STAFF RECOMMENDATION

913 Gilmore Avenue

February 21, 2018

Application: New construction – infill and outbuilding
District: Waverly-Belmont Neighborhood Conservation Zoning Overlay
Council District: 07
Map and Parcel Number: 11801028900
Applicant: Bryan Shaffer
Project Lead: Paul Hoffman, paul.hoffman@nashville.gov

SITE PLAN

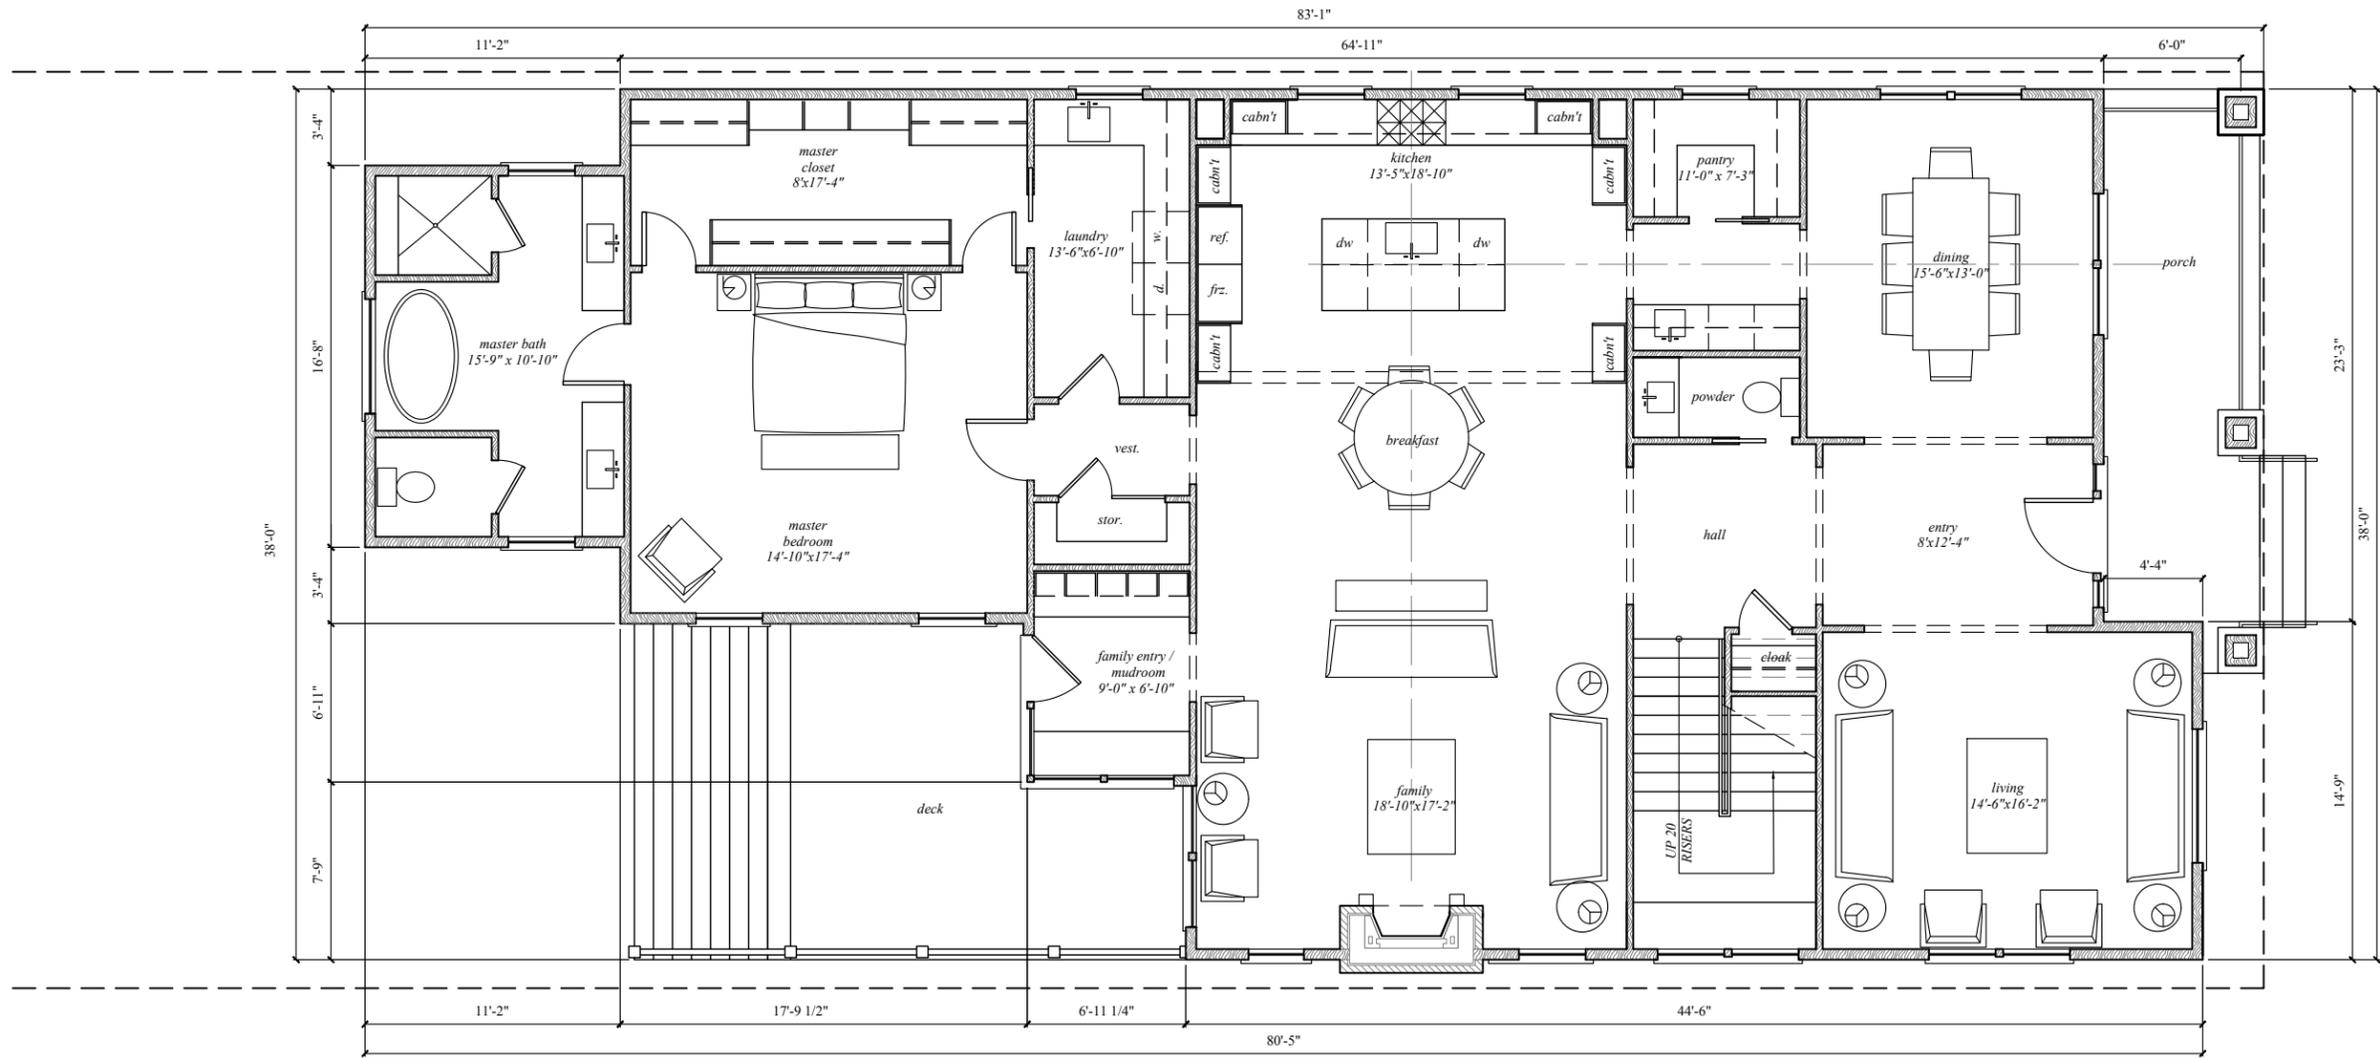
Setback & Rhythm of Spacing: The proposed new building meets all base setback requirements. It will be centered on the lot, six feet (6') from the side property lines, and fifty-four feet (54') from the rear property line. These dimensions meet the required five feet (5') on the sides and twenty feet (20') setback at the rear.

Orientation: The house is appropriately oriented towards Gilmore Avenue. The entrance faces the street and is located behind a front porch with a depth of six feet (6'). The site plan does not indicate a walkway to the street, which is typical in the neighborhood. Vehicular access to the garage will be via the rear alley, which is appropriate. With the condition that a front walkway is added from the house to the street, Staff finds that the infill's orientation meets Section III.F of the design guidelines.

Appurtenances & Utilities: The site plan does not indicate walkways or driveways. Staff recommends having approval of these features, indicated on a revised site plan, prior to construction. The location of HVAC and other utilities was not indicated. Staff recommends that the HVAC be located on the rear façade, or beyond the midpoint of the house on a side façade. With these conditions, Staff finds that the appurtenances and utilities meet Section III.I of the design guidelines.

1. The finished floor height shall be consistent with the finished floor heights of the adjacent historic houses, to be verified by MHZC staff in the field;
2. Staff has final approval of the masonry, windows, doors and garage doors, trim, porch materials, and roof color;
3. A front walkway is added from the porch to the street, to be indicated on a revised site plan;
4. The HVAC shall be located behind the house or on either side, beyond the mid-point of the house.

GARAGE PLAN AND
ELEVATIONS

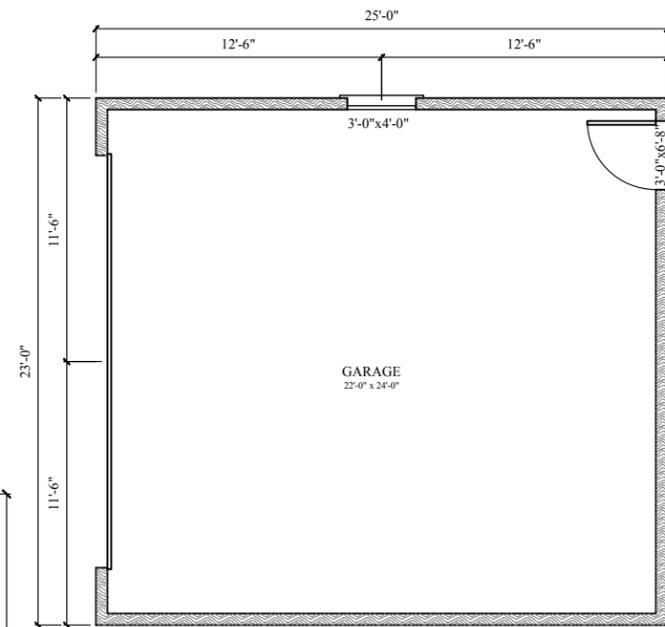
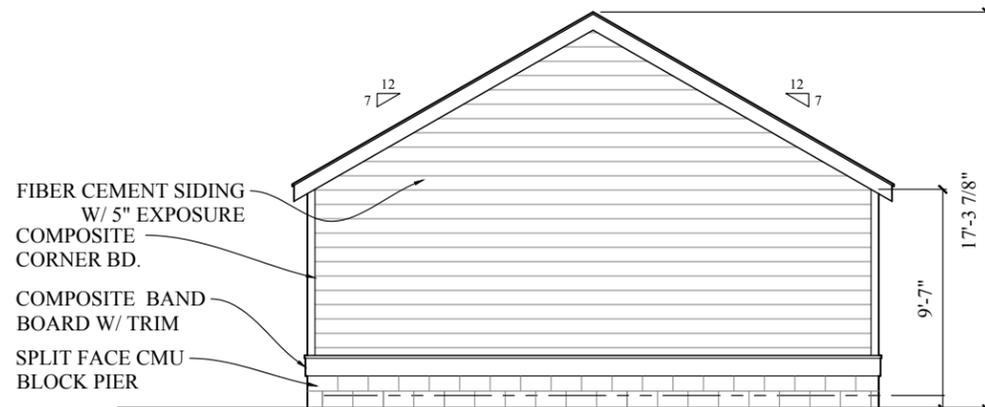
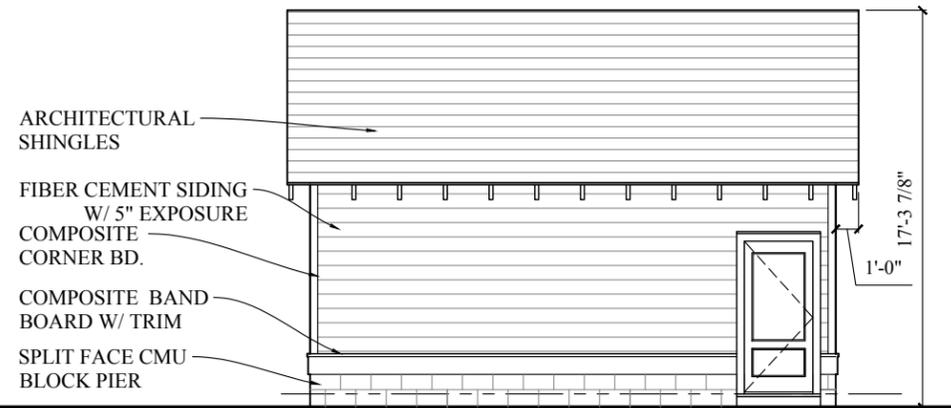
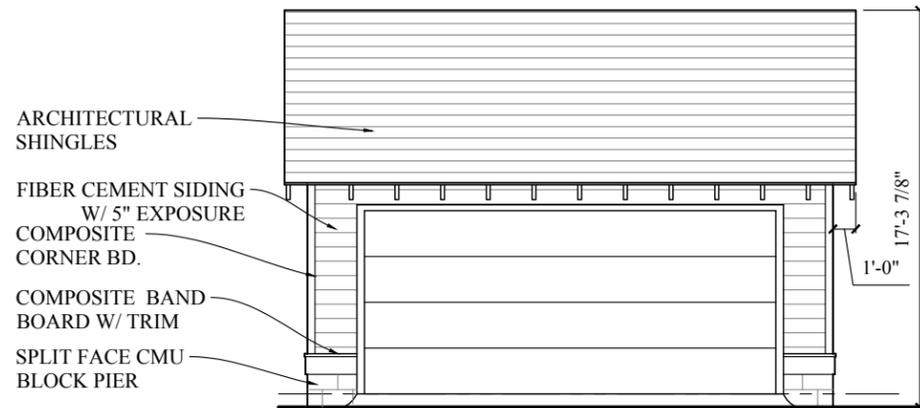
Outbuilding: The applicant is proposing an outbuilding at the rear of the lot. It will be one story with a footprint of five hundred and seventy-five square feet (575 sq. ft.).

Potential maximums	Existing conditions (height of historic portion of the home to be measured from finished floor)	Proposed
Outbuilding Ridge Height	25'	32' 6"	17'
Outbuilding Eave Height	10'	10'	9' 4"

Proposed Element	Proposed Form	Typical of district?
Outbuilding primary form	Side Gable	Yes
Primary roof pitch	7/12	Yes

Proposed	Color/Texture	Approved Previously or Typical of Neighborhood
Foundation	Split face block	Natural color	Yes
Cladding	Fiber-cement, 5" reveal	Smooth	Yes
Roofing	Architectural composite shingle	Not indicated	Yes
Trim	Composite	smooth	Yes
Windows	Not indicated	n/a	Yes
Pedestrian Door	Not indicated	Not indicated	Yes
Vehicular Door	Not indicated	Not indicated	Yes

Minimum	Proposed
Outbuilding rear setback	5'	10'
Outbuilding left side setback	3'	5'

Outbuilding right side setback	3'	20'
Distance between outbuilding and primary structure	20'	23'

With the staff's final approval of the windows, doors, garage doors and the color of roofing, staff finds that the materials meet Section III.H.4 and III.H.5 of the design guidelines.
